To: Prospective Bidders  
From: Wold Architects and Engineers  
Date: July 30, 2014  
Comm. No: 133024

Subject: **Addendum No. 3** for Bidding Documents for the: **Courthouse Renovations Phase I & II**

This addendum forms a part of the Contract Documents dated July 3, 2014. Acknowledge receipt of this Addendum on the space provided on the Bid Form. Failure to do so may result in disqualification of Bid.

**M1.01**

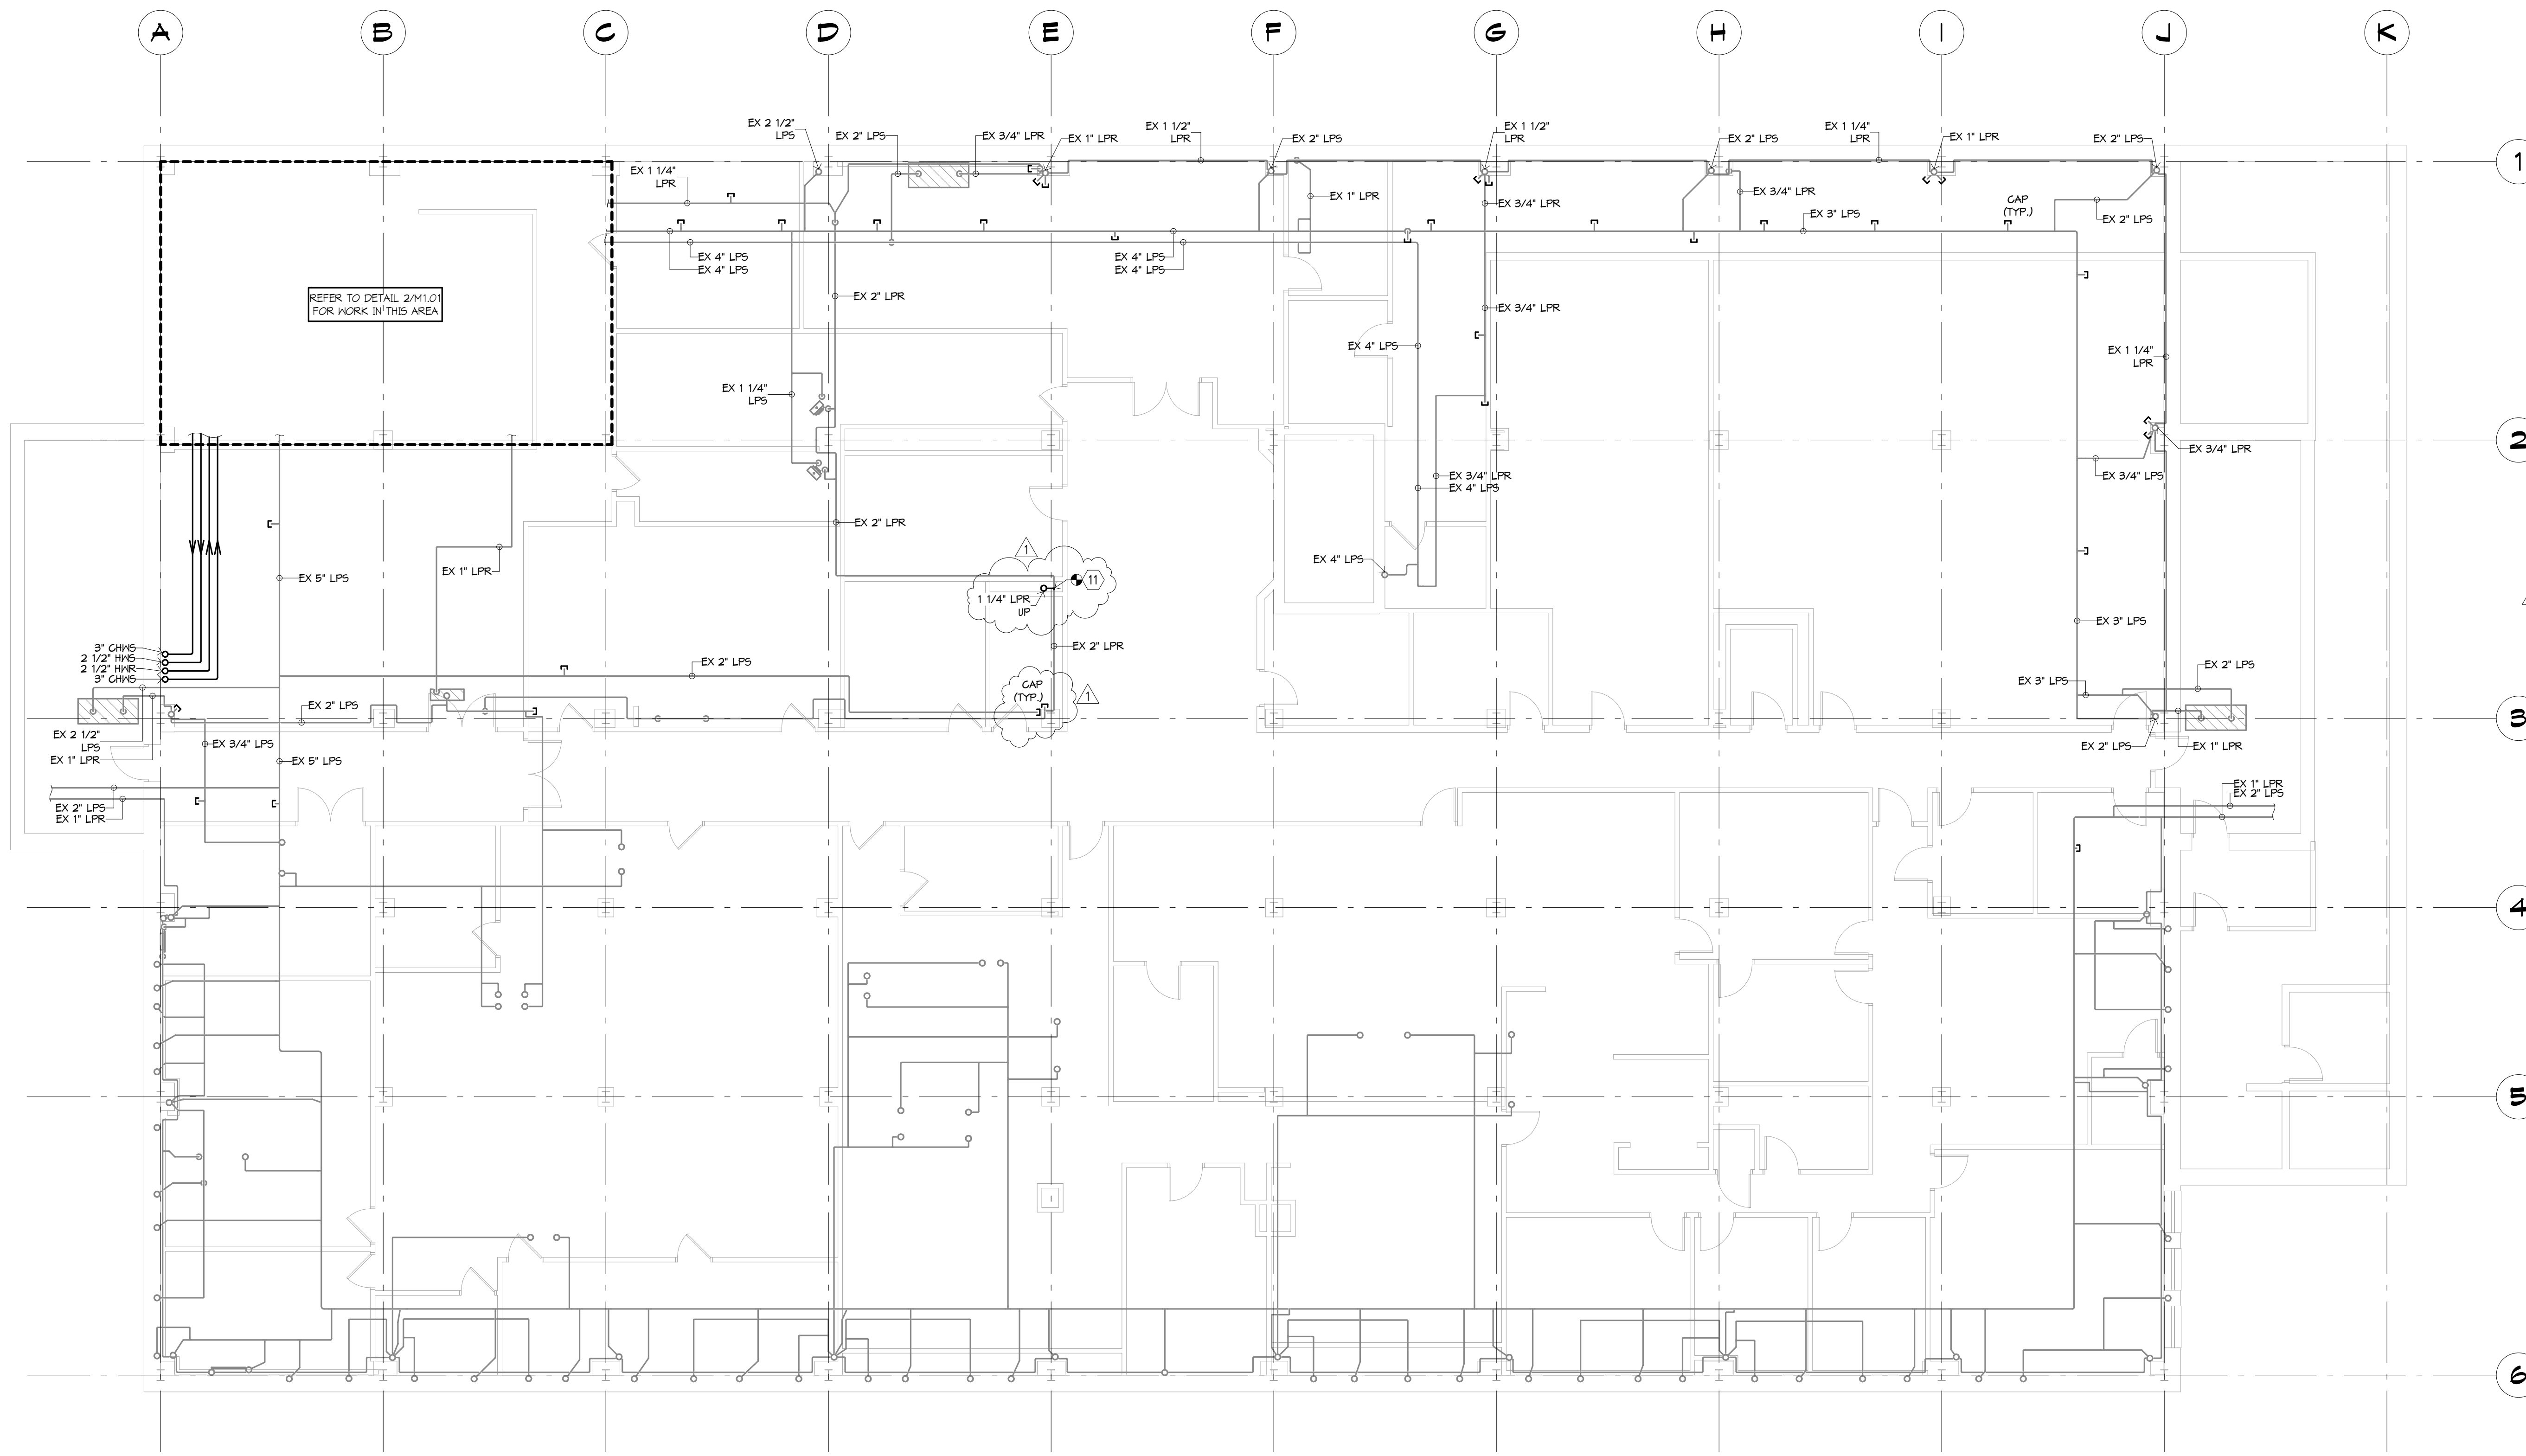
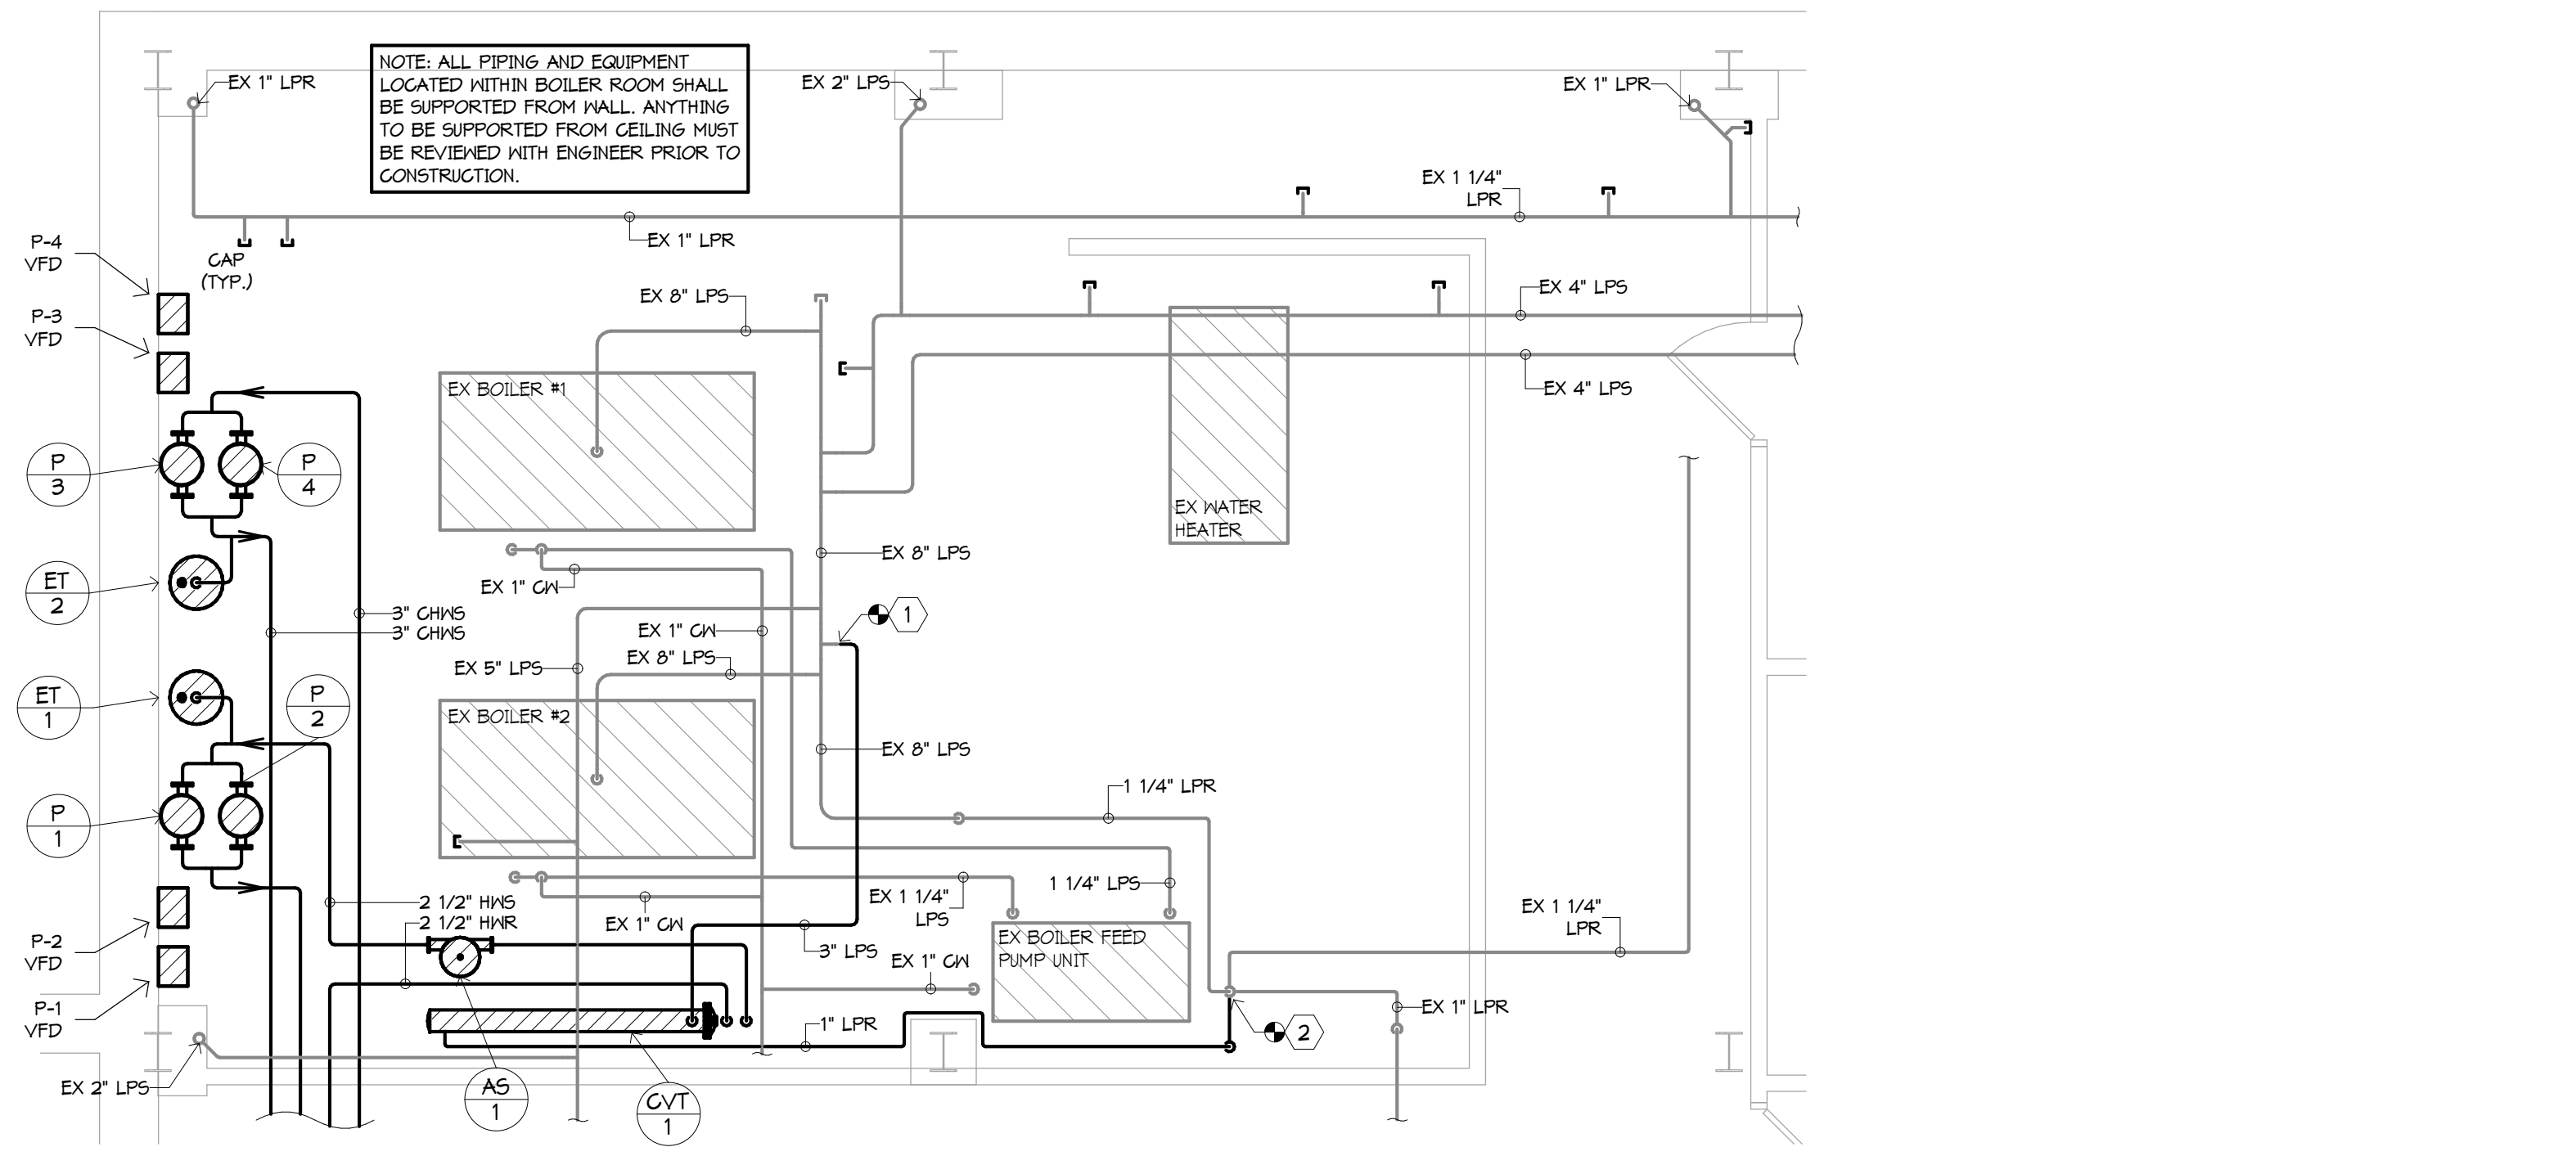
A. Refer to attached Sheet M1.01 for revised condensate drain pipe routing.
10. **SHEET M1.11 – MAIN LEVEL HYDRONIC PIPING AND BAS PLAN**  
A. Refer to attached Sheet M1.11 for revised condensate drain pipe routing in Attorney/Client Room (A153).
